Re: **Self-storage**
Project #: PR-2024-010074
Application #: SI-2024-01090

Please find the following responses addressing comments received for a hearing dated August, 7 2024. In an effort to address your comments concisely and simplify your review of these development plans, we have summarized your comments and our responses below. Your comment is listed first, followed by the response in Bold.

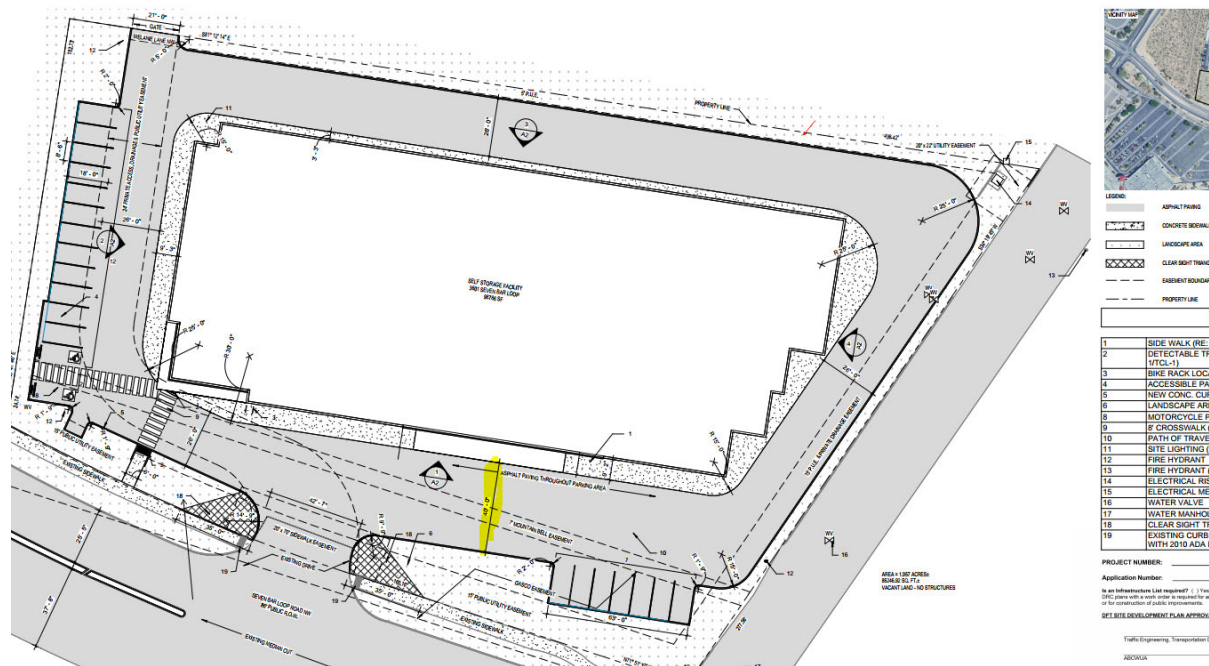
3. In all zone districts, mechanical equipment shall be screened from public view from streets adjacent to the lot or from adjacent properties. The design of mechanical equipment screening shall be compatible with, and be an integral element of, the building structure. Location of such equipment within the building or at ground level is preferable to roof-mounting, unless such location would adversely affect the streetscape, pedestrian circulation, or open space.

Response: The mechanical equipment will be screened.
